### BULLETIN NO. 6

491/20167.SDW - PHASE 500:  
CENTER FOR FORENSIC PSYCHIATRY- CREATE KITCHEN  
SALINE, MICHIGAN

WTA Project No. 2021094  
NOVEMBER 05, 2025

PROJECT NUMBER 2021094	SHEET NUMBER A7.01
PROJECT DATE SEPTEMBER 6, 2023	
CHECKED BY C.D.S.

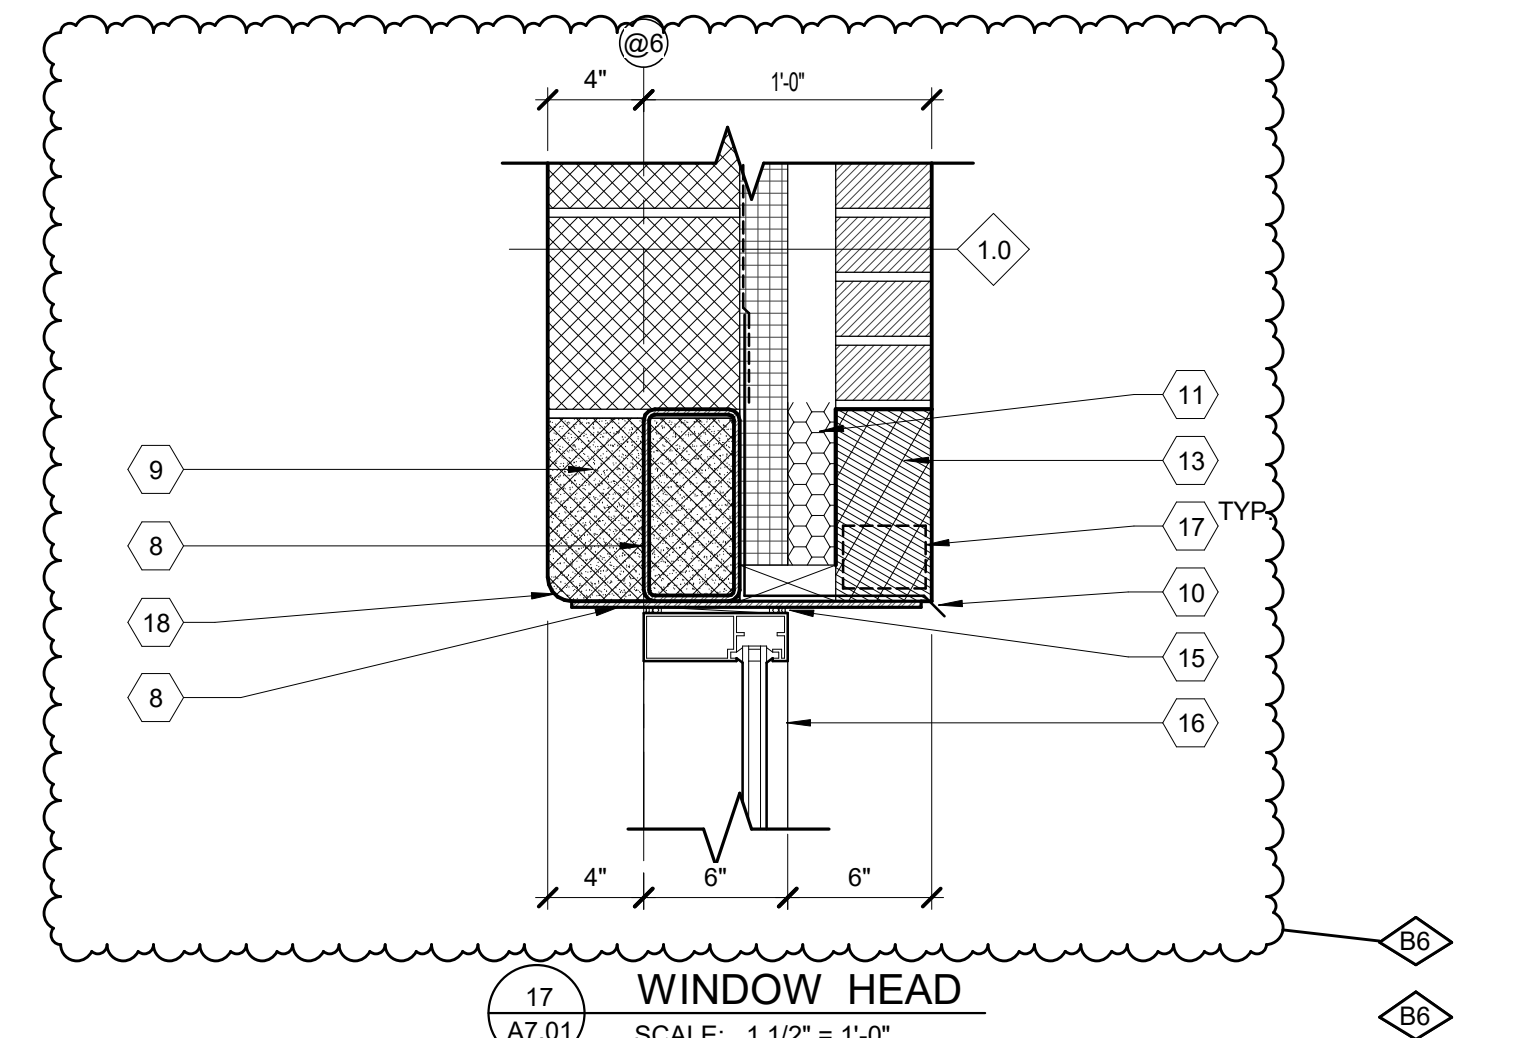
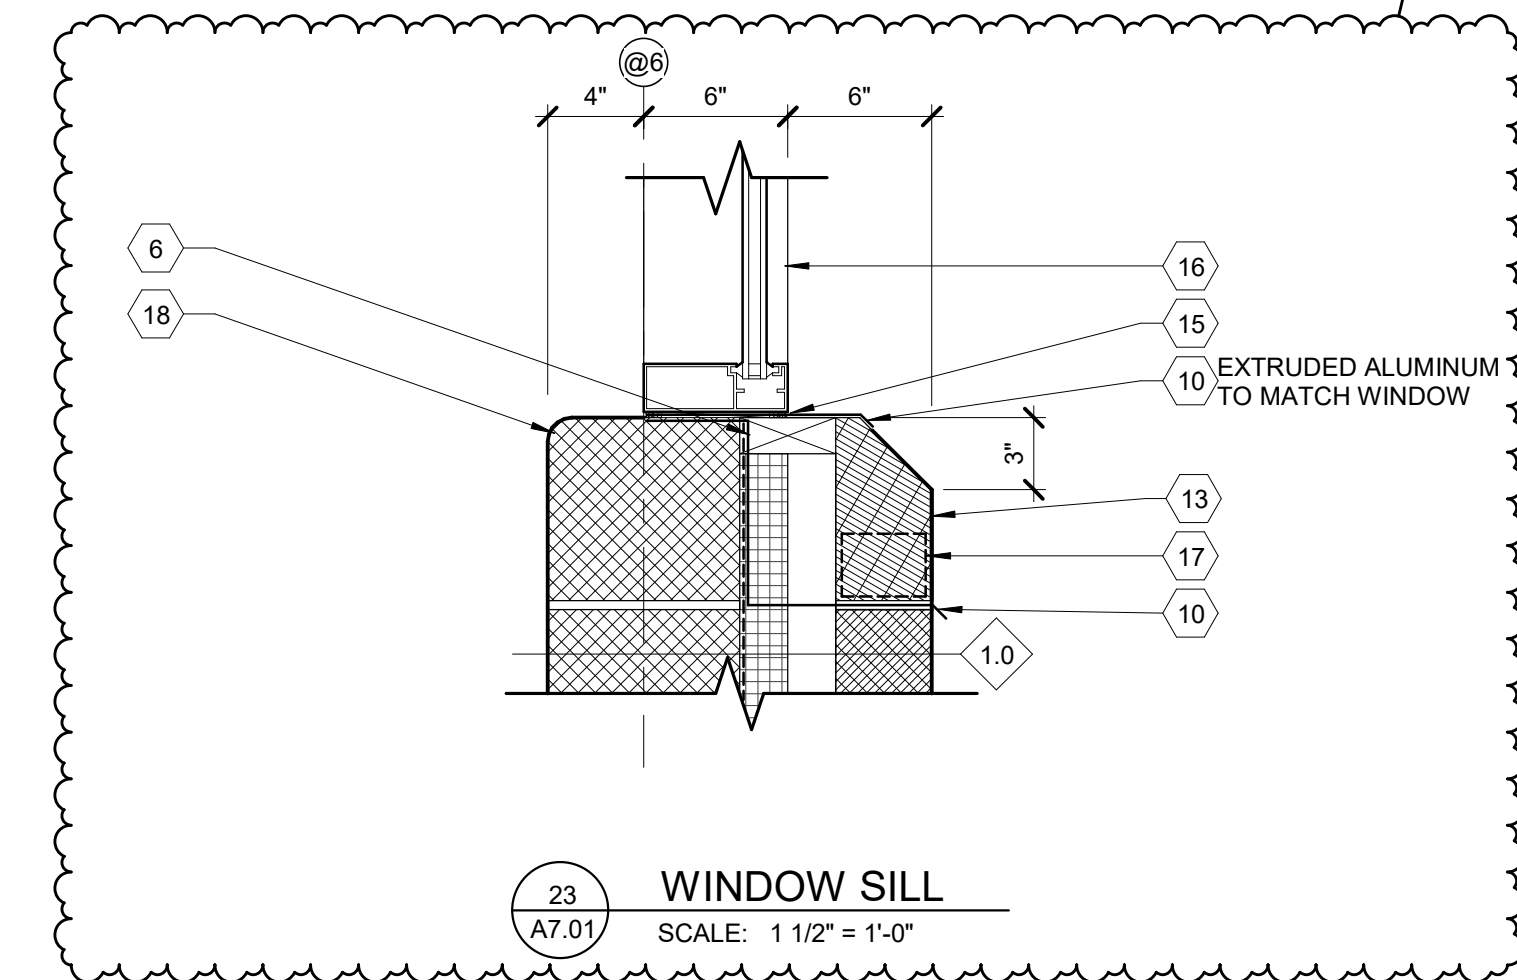
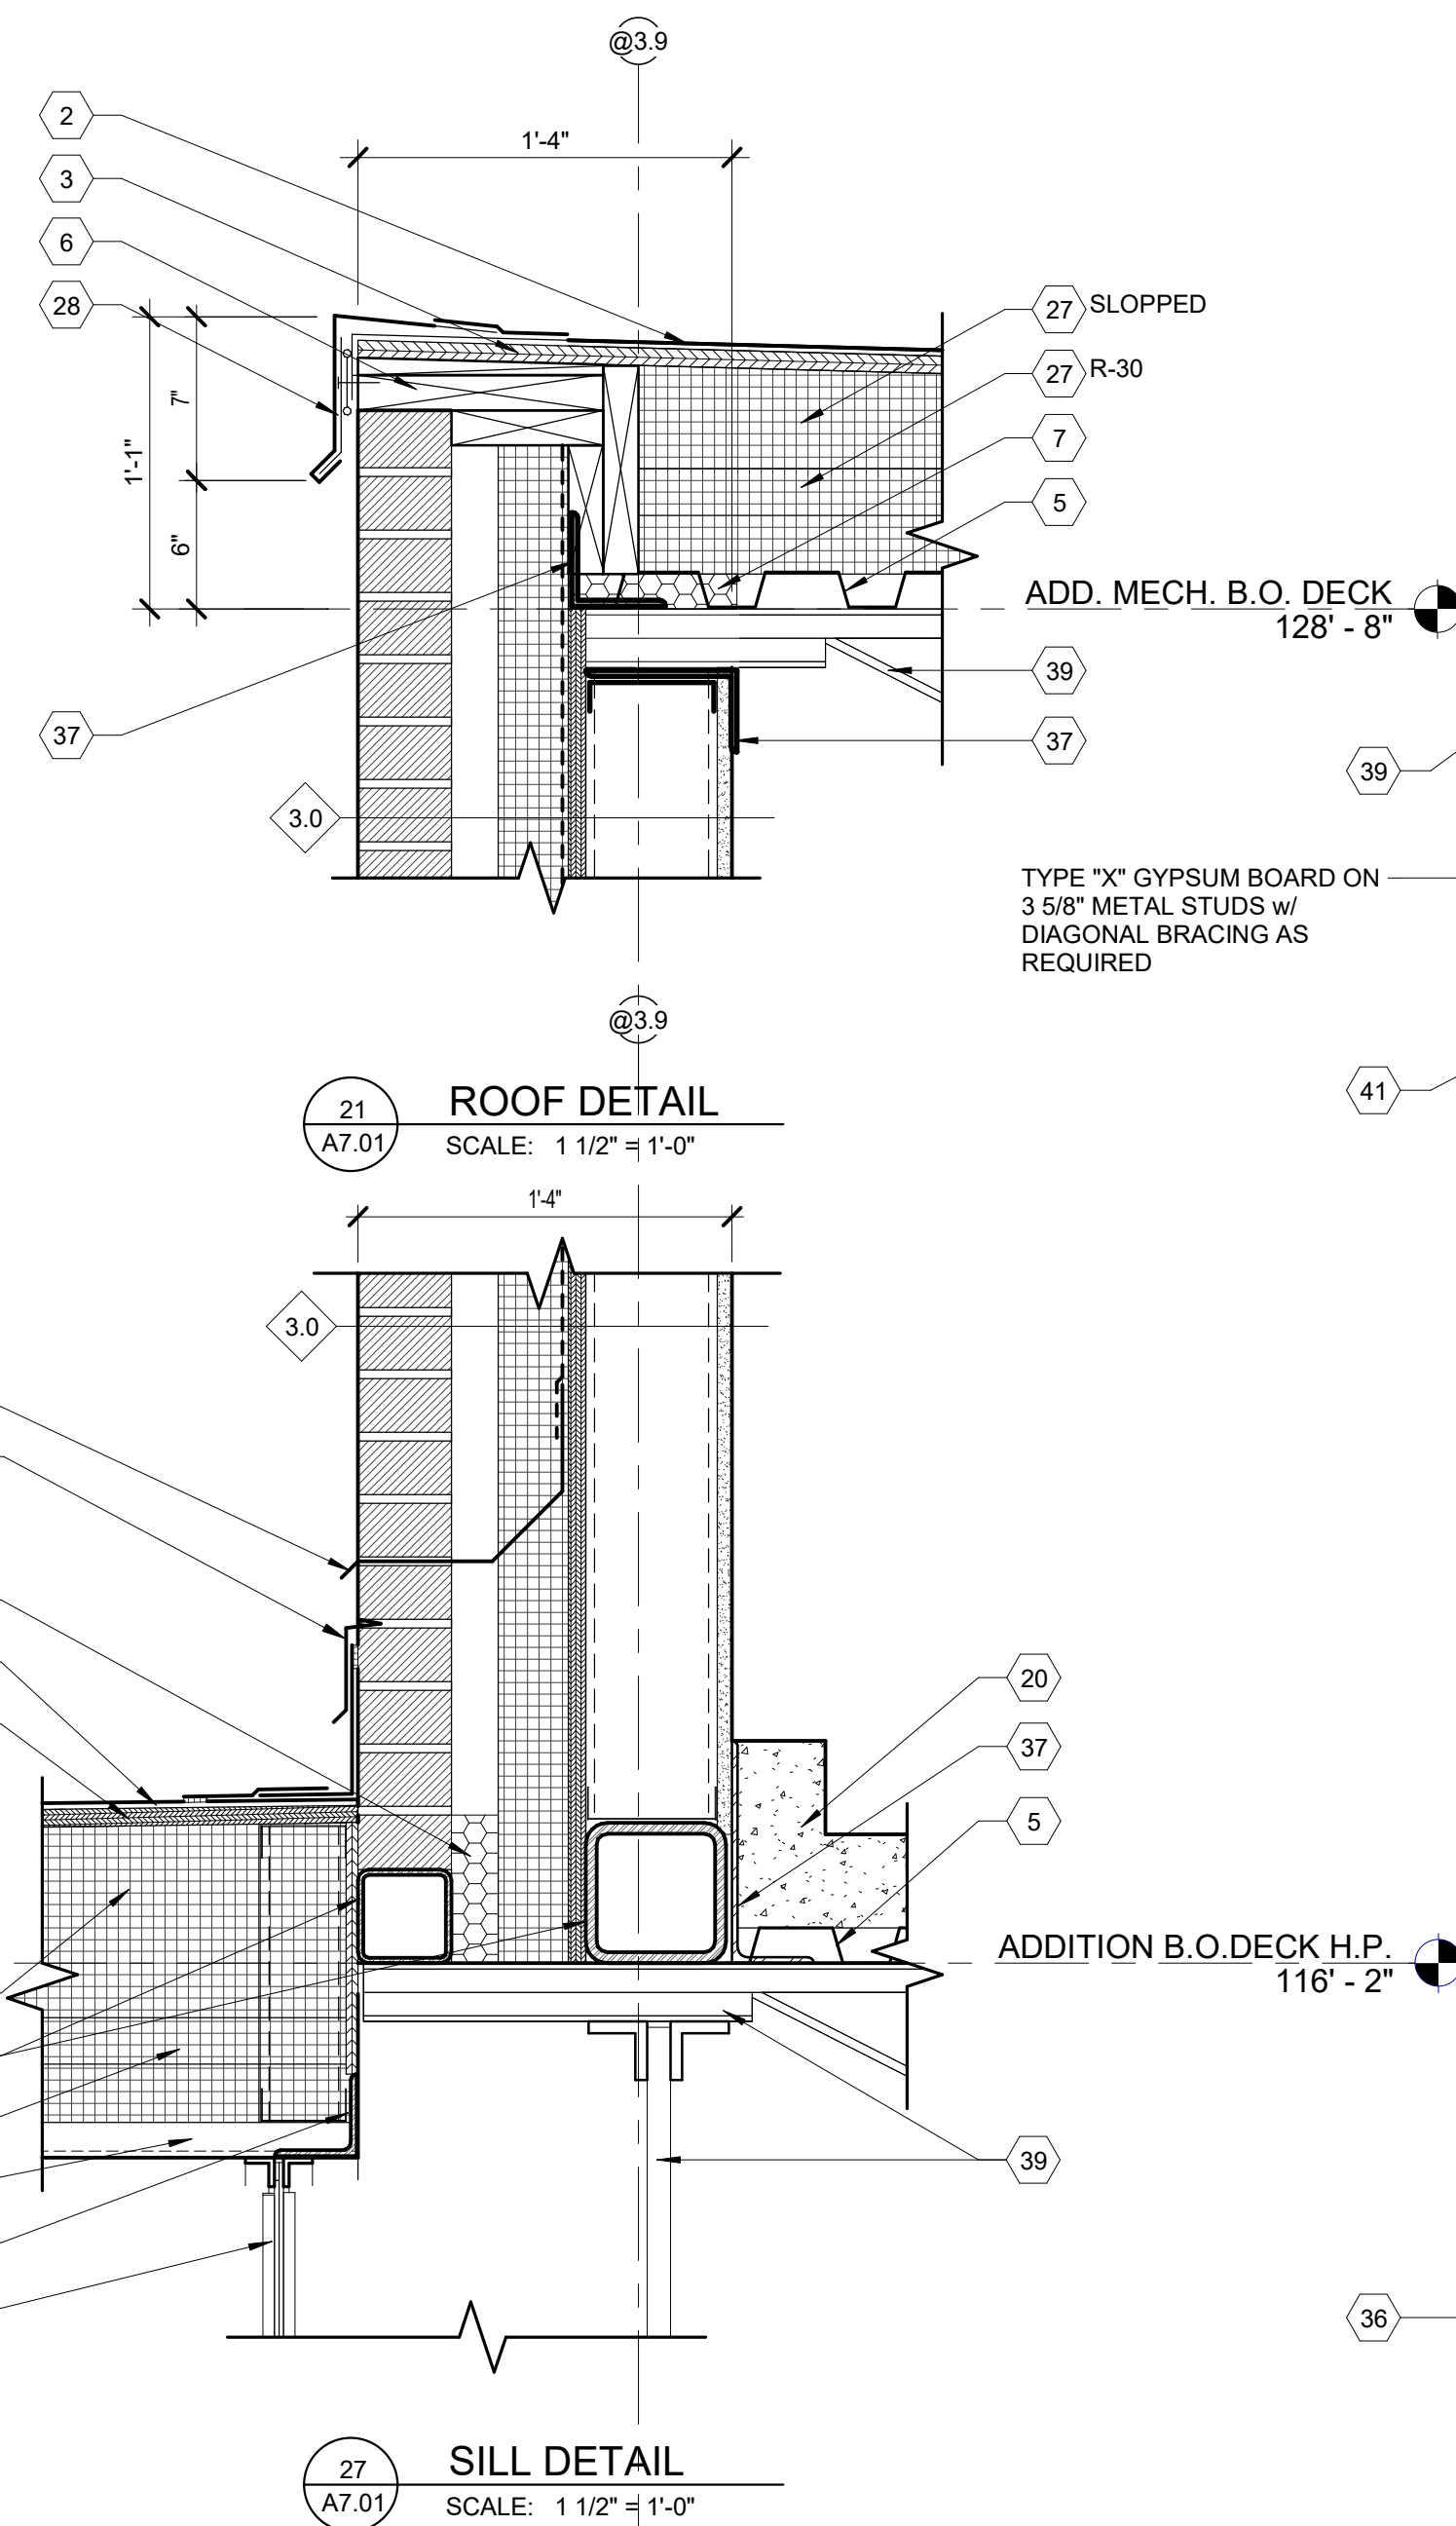
- Item A1      Reference Sheet A2.31, A7.01 **(Re-issued)**
- A. Revised windows to sit 6" from the face of the exterior wall in lieu of 3".
  - B. Added thru wall flashing, extruded aluminum flashing, and weeps under the window as indicated on attached sheets.
